**Title:** Permit Application 20-071: 4512 North Ave, Edina

# Technical Memo

**Permit Name:** 4512 North Avenue, Edina - Floodplain Alteration

**Permit Number:** 20-071

4512 NORTH AVE EDINA, MN 55436		FLOOD PLAIN FILL EXHIBIT	
 4931 W. 35TH ST., #200 ST. LOUIS PARK, MN 55416 952.250.2003 / 763.213.394 www.CivilSiteGroup.com	Project Number:	19419	Revision Number:
	Issue Date:	8/25/20	Revision Date:
			<b>EXHIBIT A</b>

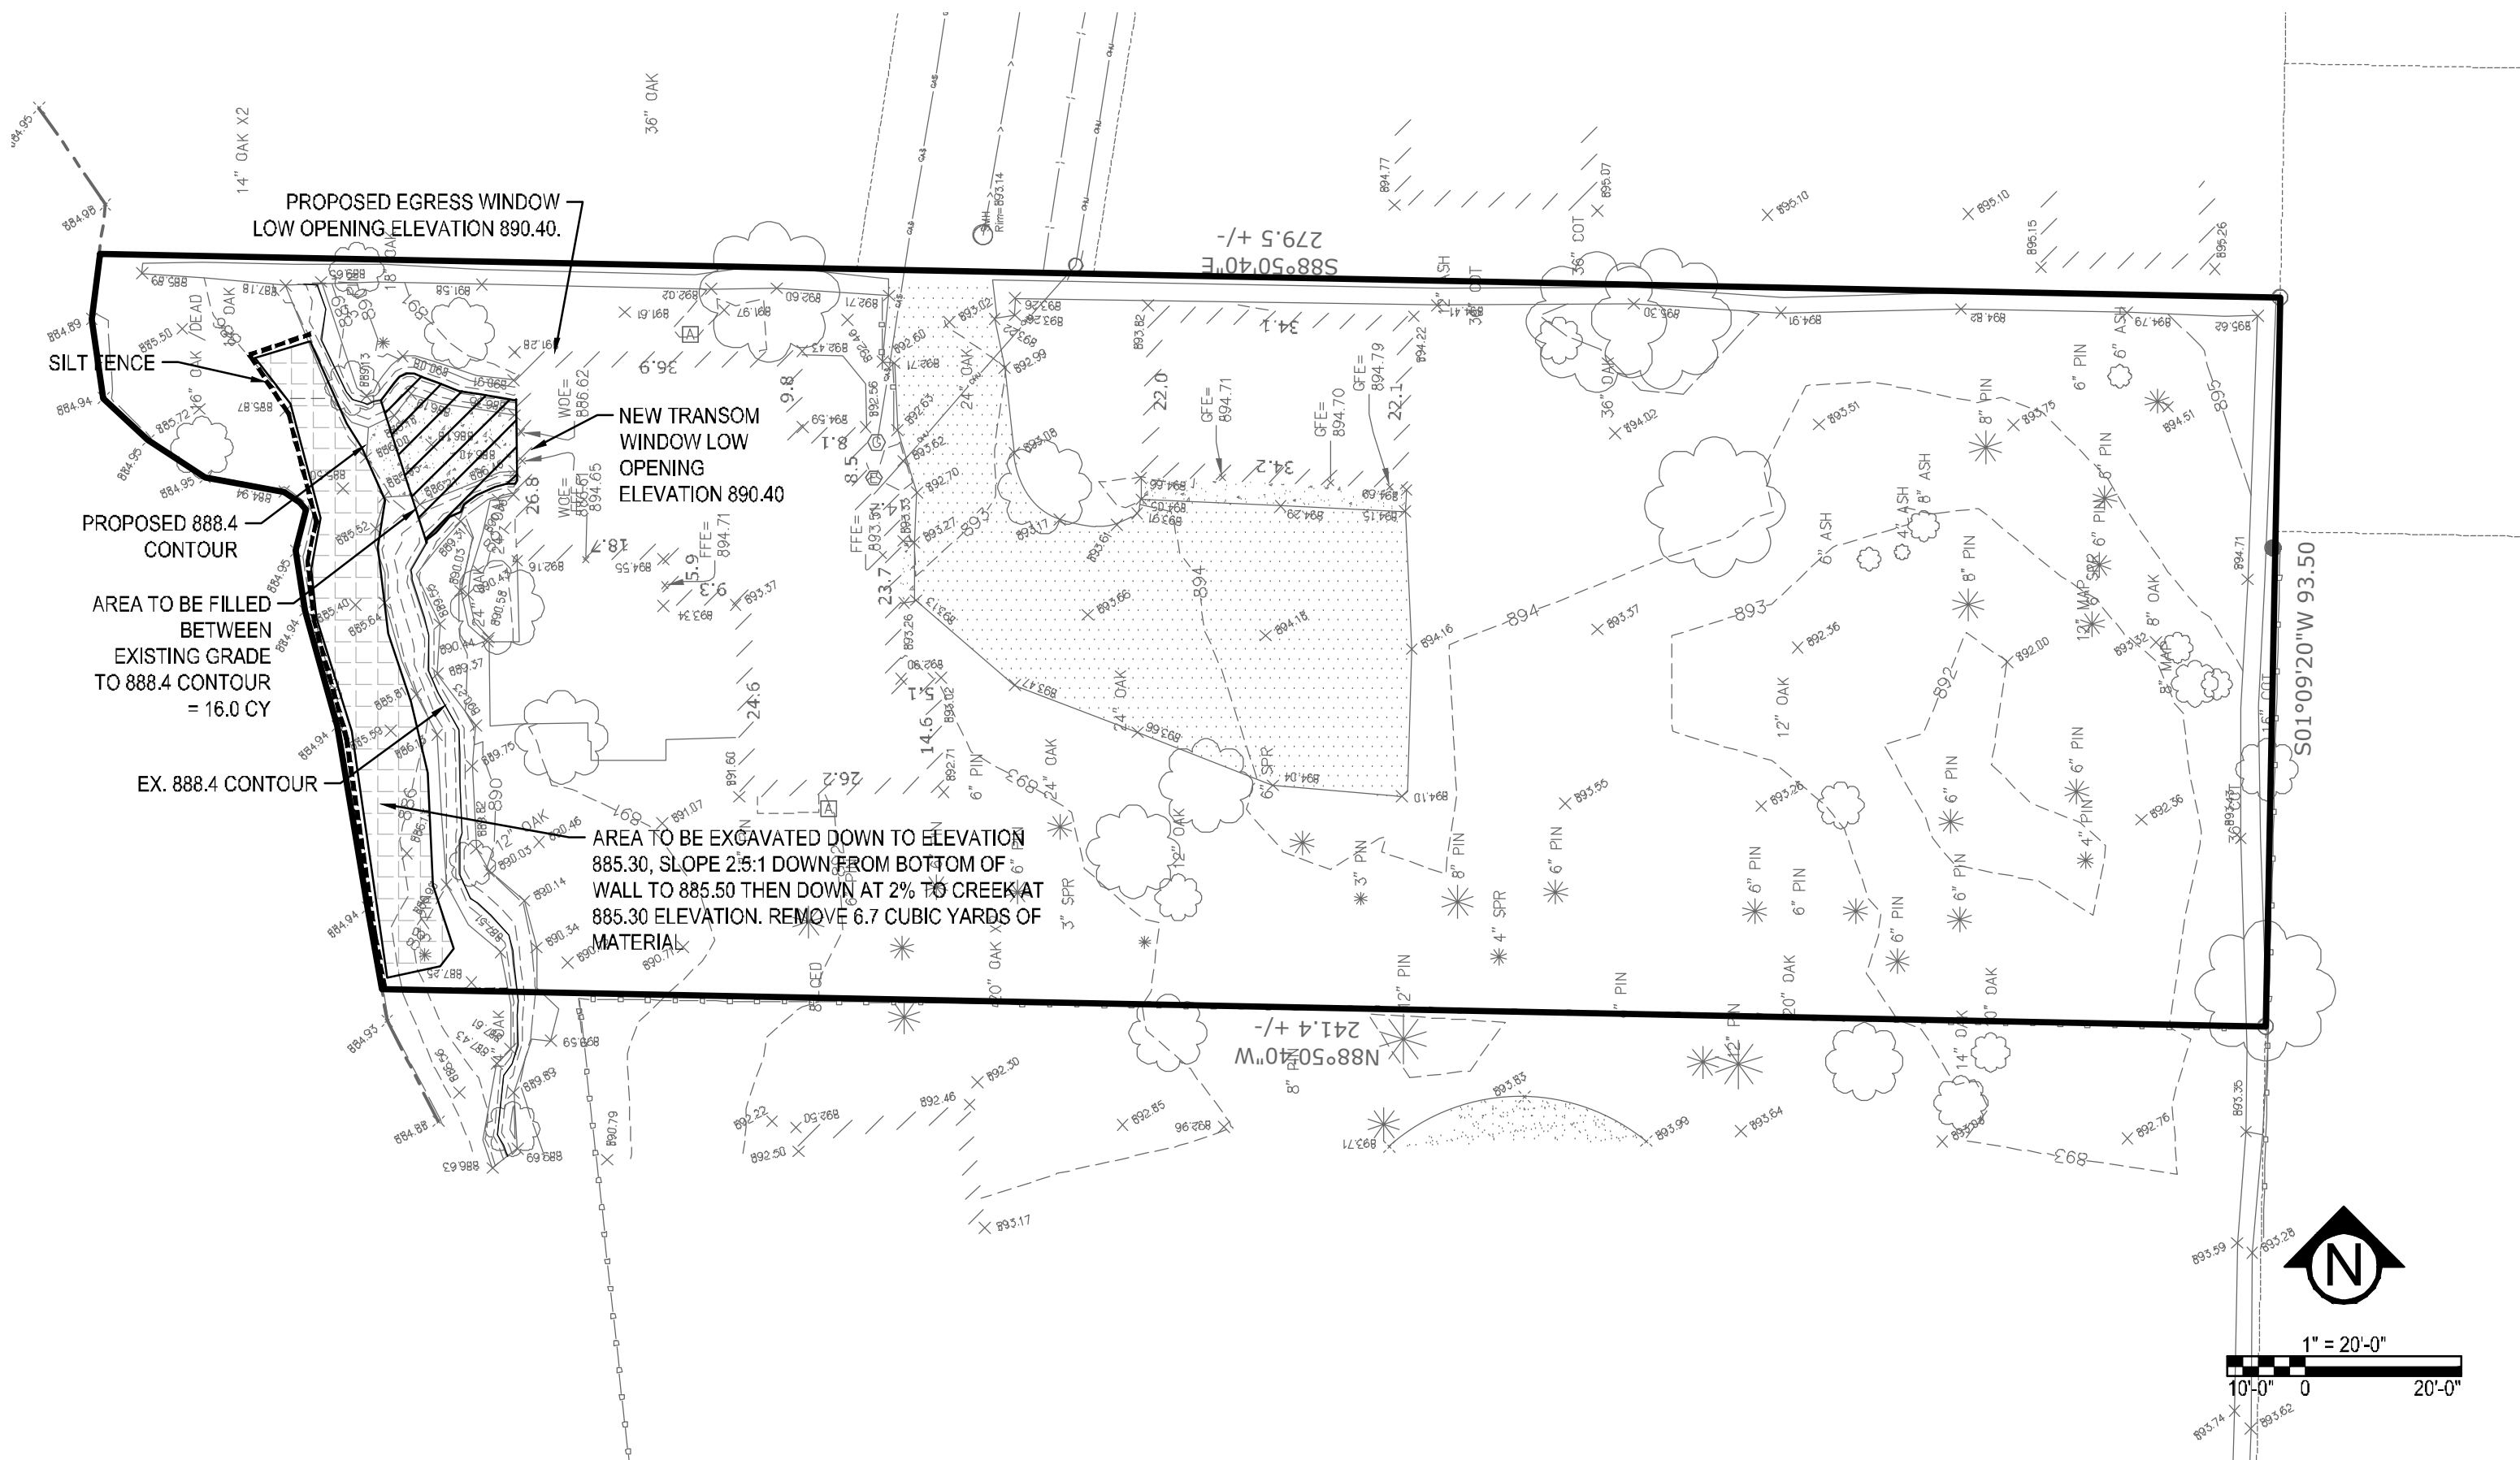
1. Reducing the amount of floodplain fill to be placed in front of the existing walkout from 20 CY to 16 CY. This was done by pulling back the area of fill in front of the structure while ensuring the property will be better protected from potential future flood events.
2. Creating floodplain storage in front of the existing retaining wall by scraping the existing banks to remove soil and create 6.7 CY of floodplain storage. This approach will also preserve existing mature trees on site.

Overall the project will cause a net decrease in storage capacity of 9.3 CY below the project 100-year high water elevation of Minnehaha Creek.

Per Section 3(a) of the Floodplain Alteration Rule, the project is required to provide mitigation volume at a 1:1 ratio. The applicant states that they are unable to provide the mitigation on-site and are seeking a variance (Attachment 1) from the requirement.

As a result of the site modifications the proposed variance is recommended to be approved as it minimizes floodplain encroachment while balancing hardship on the site for the property.
